# **Pearl Place Buildings 1 & 2**

**ADDENDUM IV**

**October 11, 2006**

## **Addendum #4**

SOUTHWEST ELEVATION

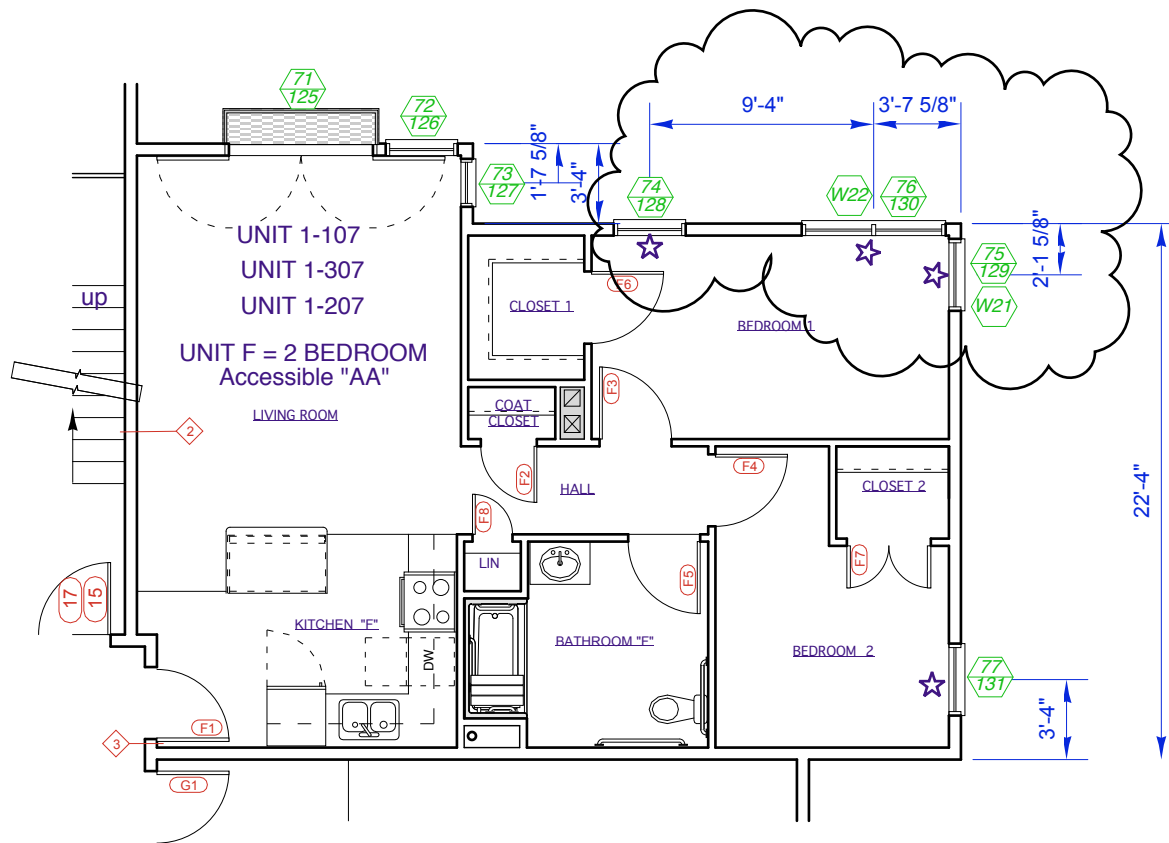
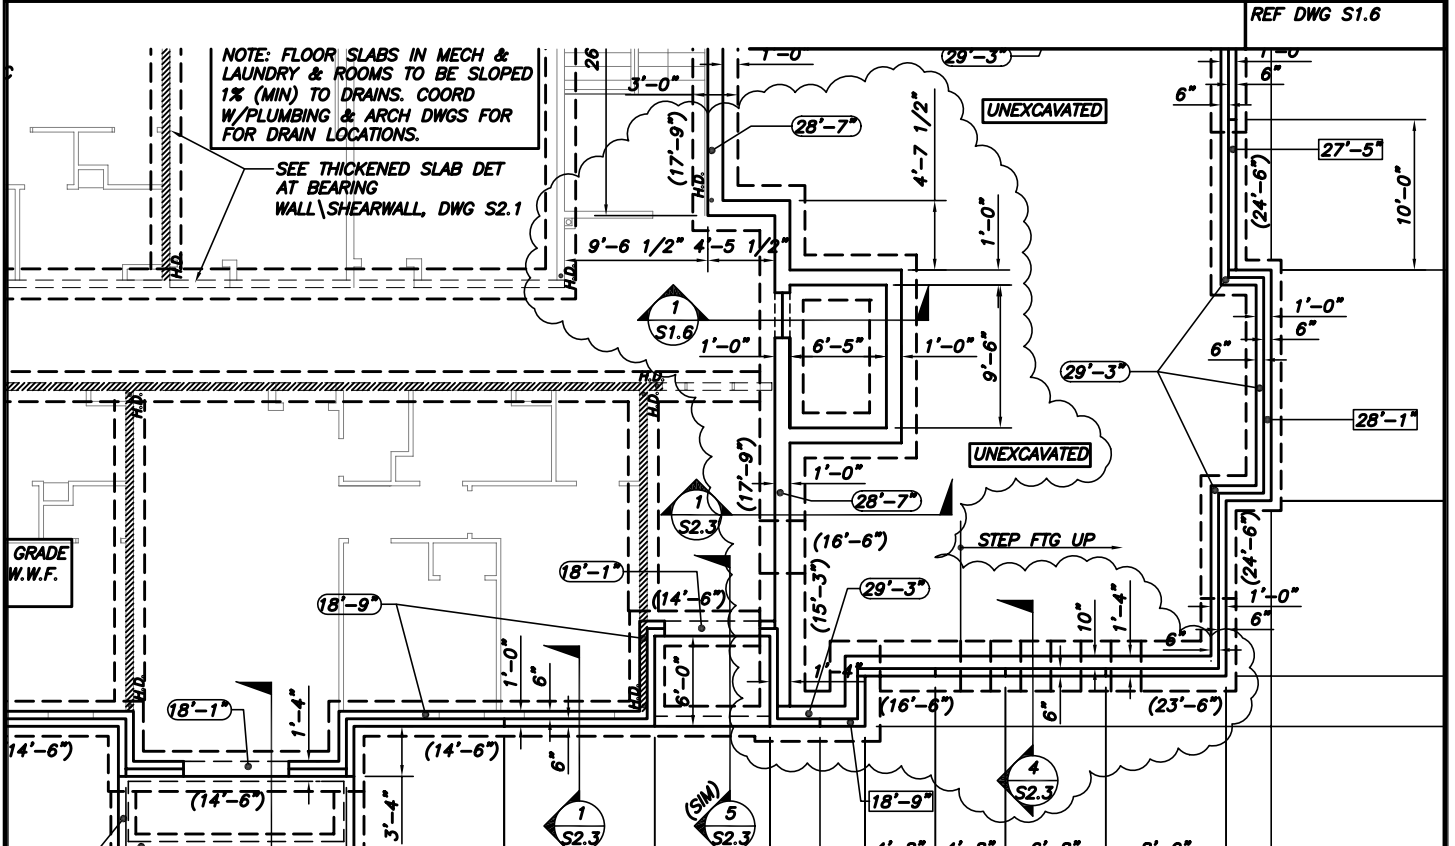
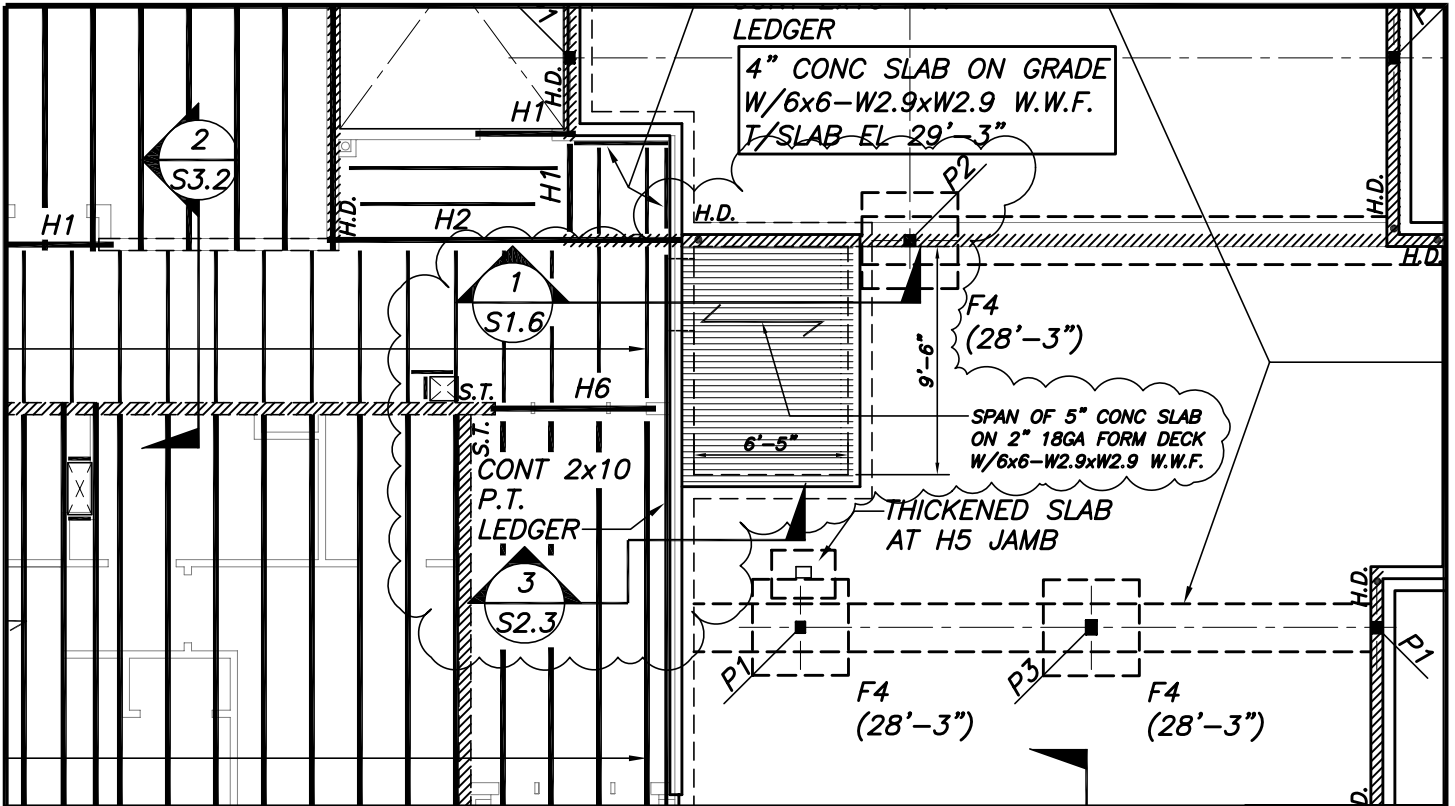
At Southwest Elevation change double windows to single windows and  
At Southeast Elevation change single windows to double windows as  
shown on sketch A11.

**DRAWING PLAN & DUCTWORK CHANGES - REF. DRAWING M8**

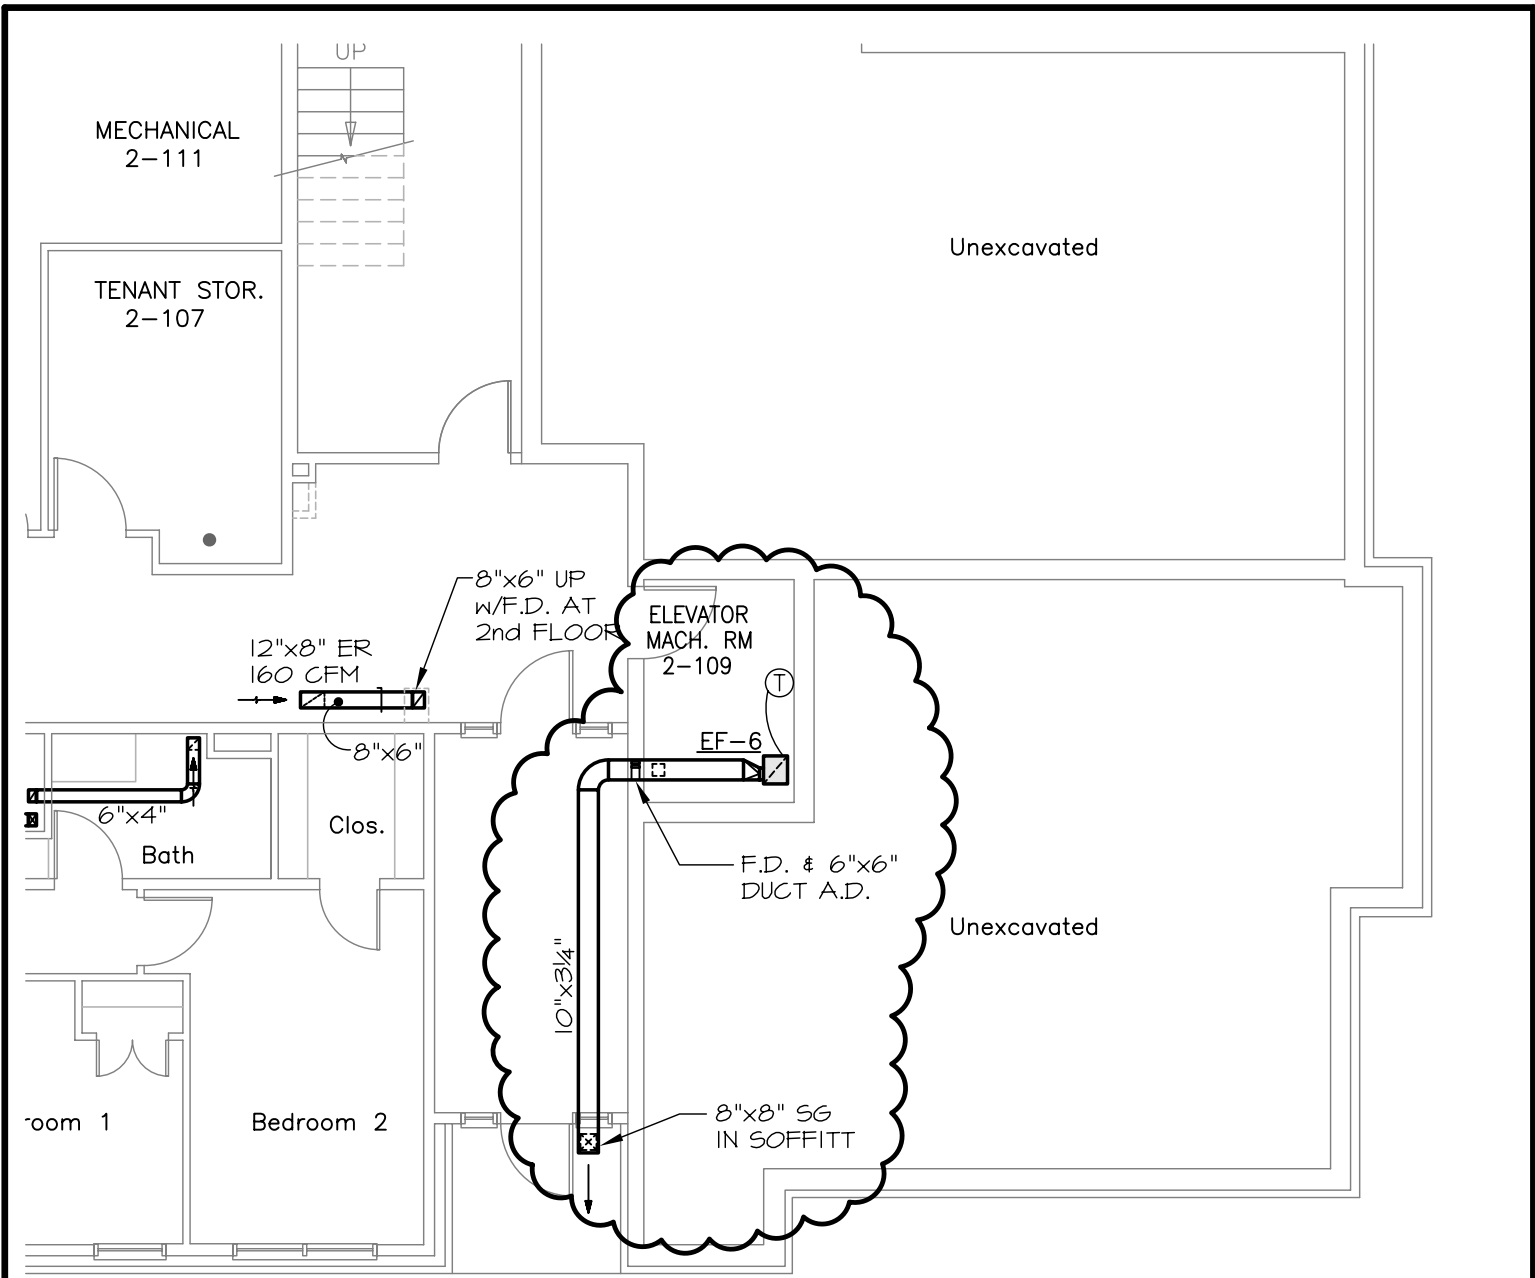
Add fire dampers as described on Change Proposal by Mechanical Systems attached to this Addendum.

Per your request, we did a more in-depth code review in response to Mike Nugent's comments regarding fire dampers. As a result of that review we are requesting the following Change Proposal to be issued prior to signing of construction contracts.

1. Provide a fire damper at all ceiling supply and exhaust registers (and grilles) within apartments and corridors and discharge grille from EF-6 (Building 2). Dampers shall be intended for installation within the ductwork immediately above each register or grille. Please modify specification section 15600, "MECHANICAL", Par. 2.21, "SHEETMETAL", sub-par. "L" to read as follows:

5. Installation shall be in accordance with damper manufacturer's instructions
2. Mount Exhaust Fan 5 (B2 Mechanical 2-111) below the gypsum ceiling.

- L. Fire Dampers
    1. Fire dampers shall be installed to comply with NFPA Code No. 90A and shall bear a U.L. label. Provide fire rated access door at each fire damper not accessible through grille. All dampers shall comply with UL555 for dynamic testing and positive closure under air flow.

2. All fire dampers for mounting in walls and floors to be provided by damper manufacturer with integral sleeves and mounting angles. Sleeves provided "in-field" are not acceptable. Models indicated are Ruskin to establish a standard: Dampers installed above ceiling registers and grilles shall be designed to mount within ductwork.

- a. Wall and floor types; Model IBDT, Style "B".
      - b. Wall type behind grilles; Model IBDT2, Style "A"
      - c. Above ceiling grilles and registers; Model CFD2W

3. Units (not located behind grilles) shall be style "B" with the curtain isolated out of the stream.
    4. Provide factory mounted fusible links designed to melt at 165°F. and close the damper.

## ELECTRICAL SITE PLAN E0.1

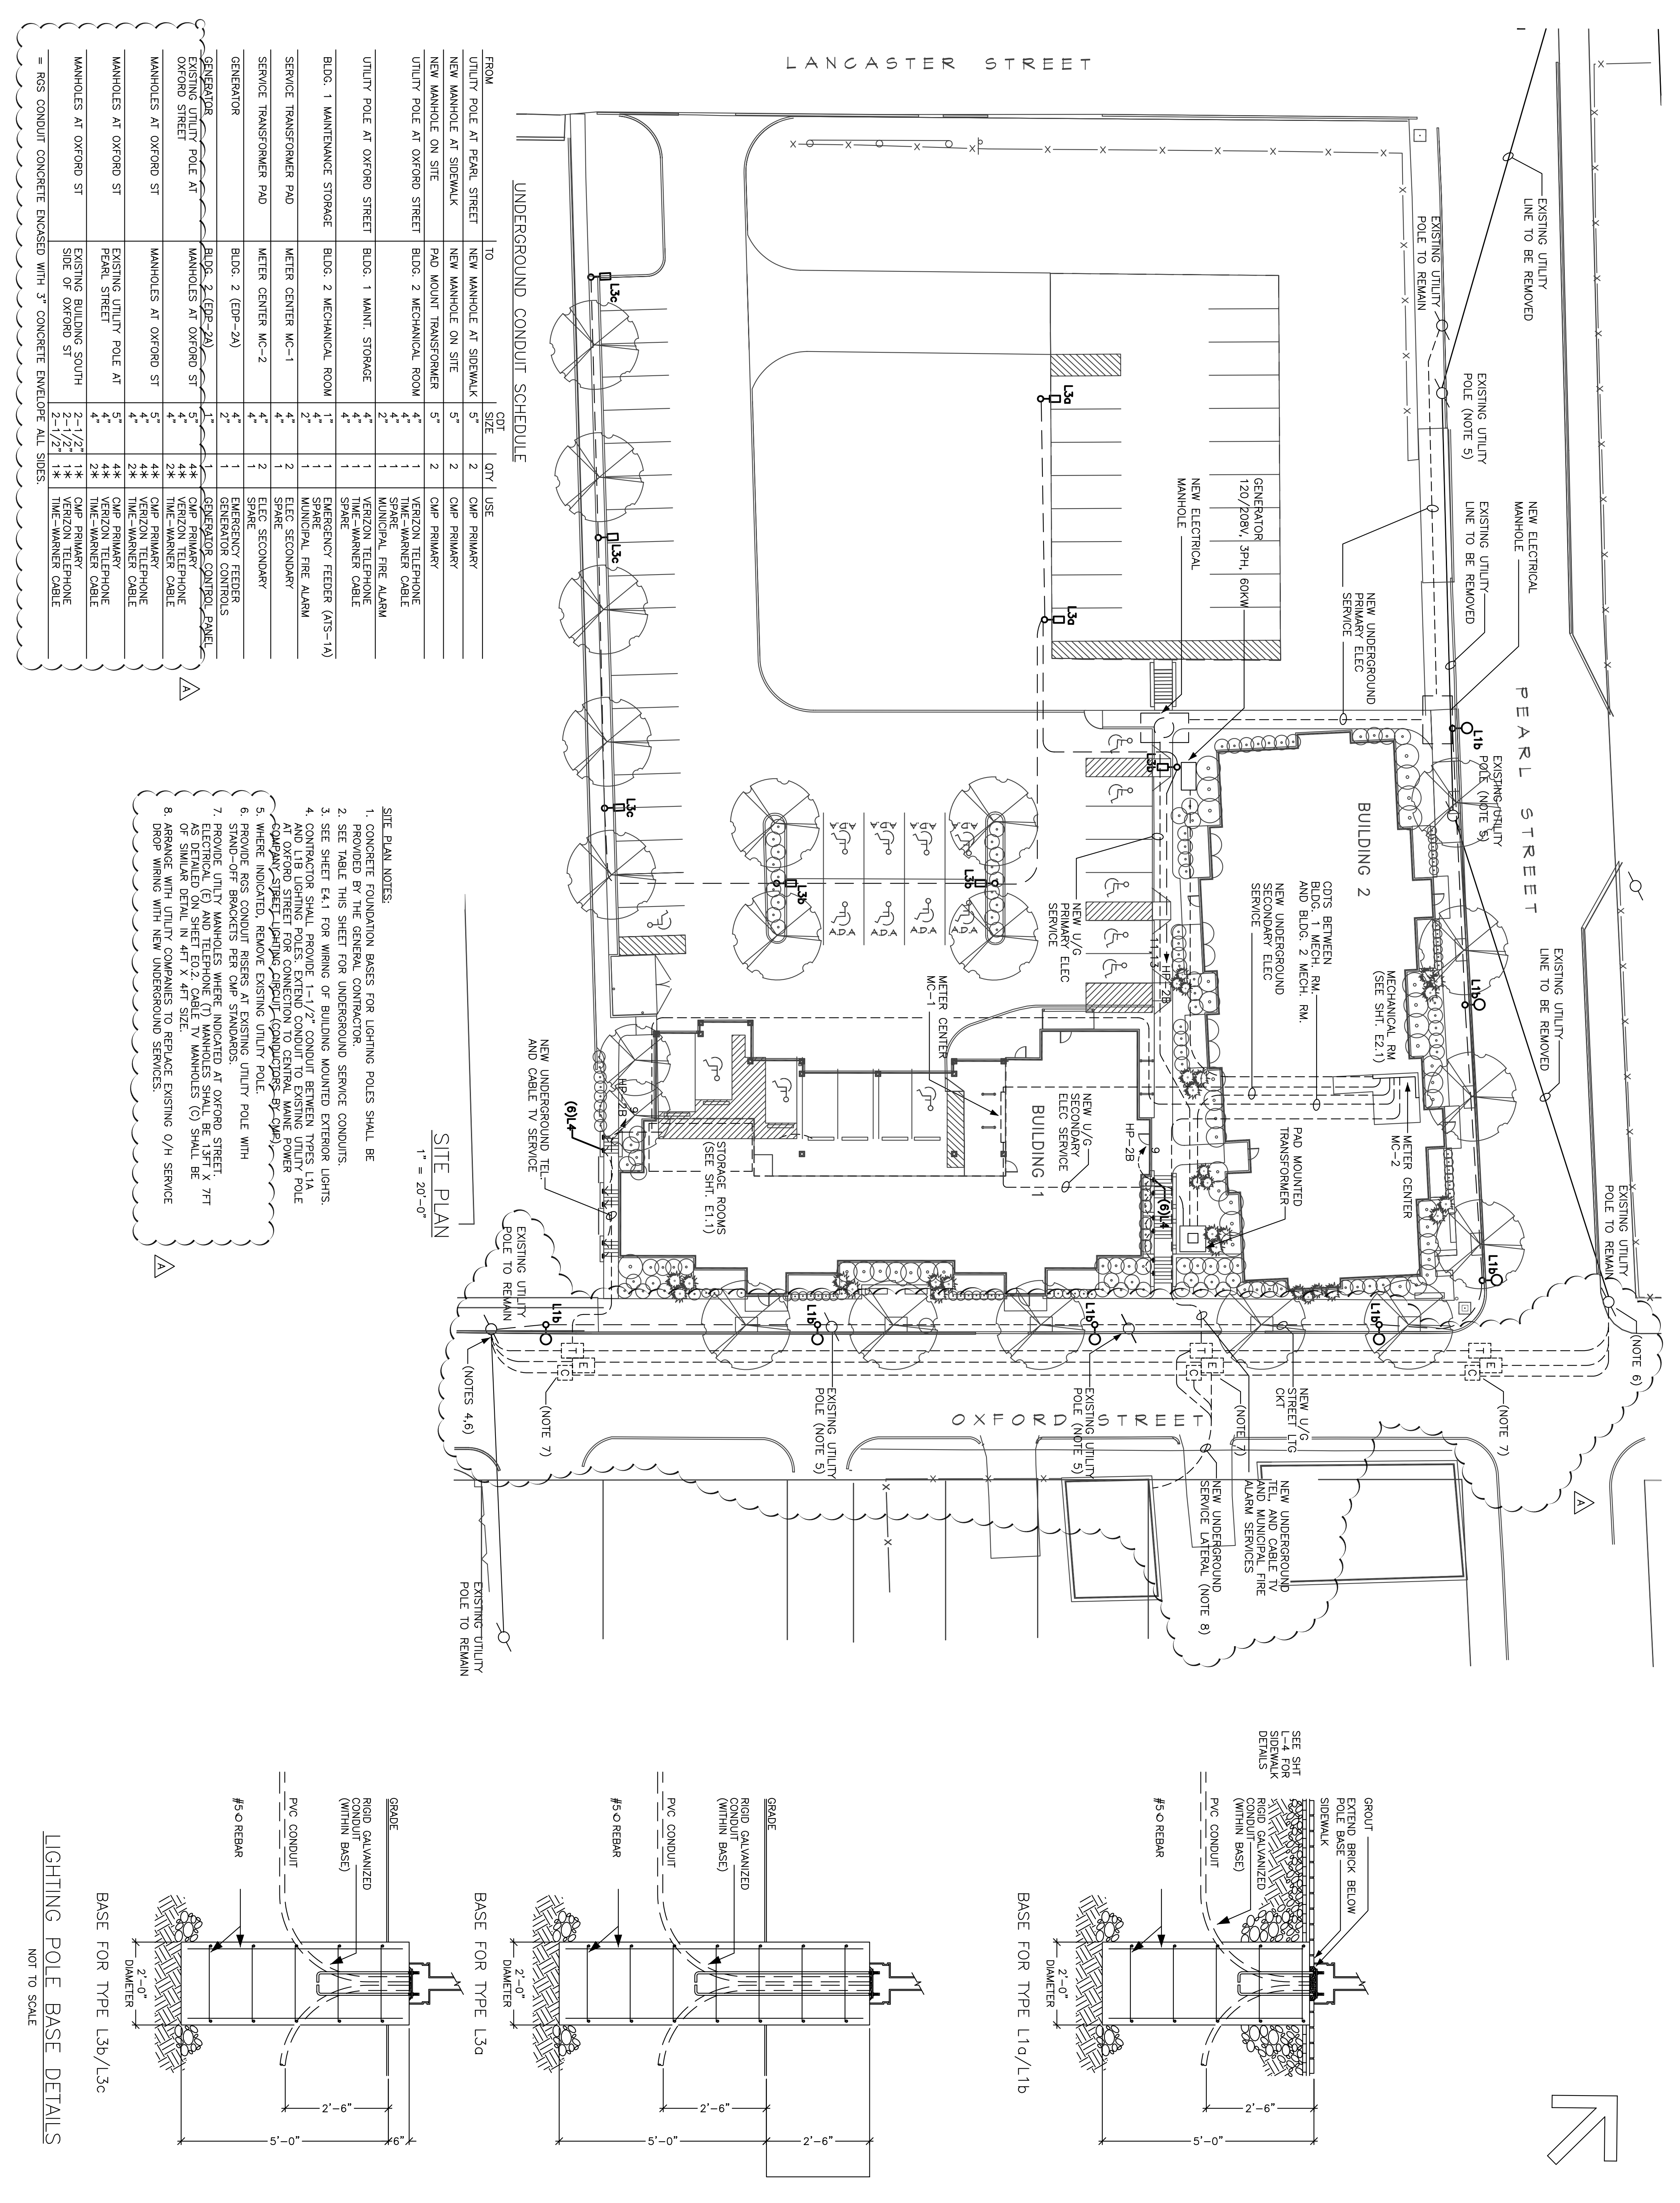
Change power on Oxford St. to underground as shown on the attached revised E0.1.

8. ARRANGE WITH UTILITY COMPANIES TO REPLACE EXISTING O/H SERVICE DROP WIRING WITH NEW UNDERGROUND SERVICES.
